Operational Readiness Clearance (Non-beam operation)

E906 SeaQuest

AUTHORIZATION TO PROCEED WITH THE UNATTENDED OPERATION OF KTeV ANALYSIS
MAGNET FOR E906 (SeaQuest)

**E906 Spectrometer Magnet, NM4AN, Operational Procedures. CNB
1/24/11**

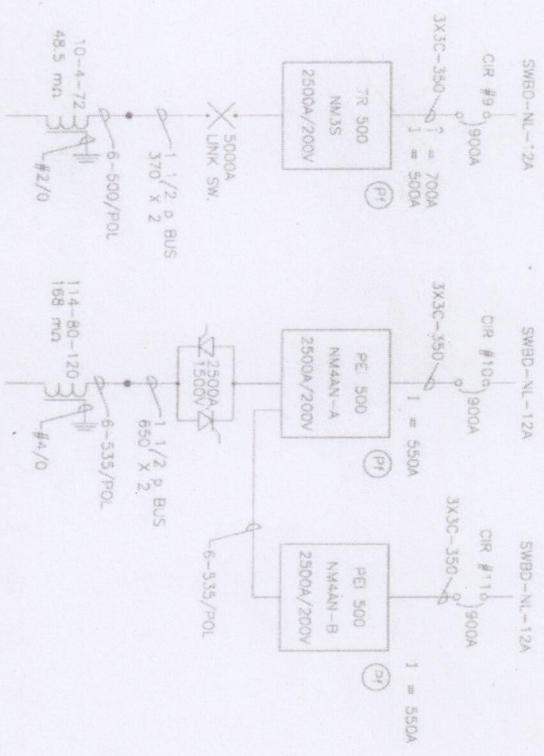
is this still true?

who

who?
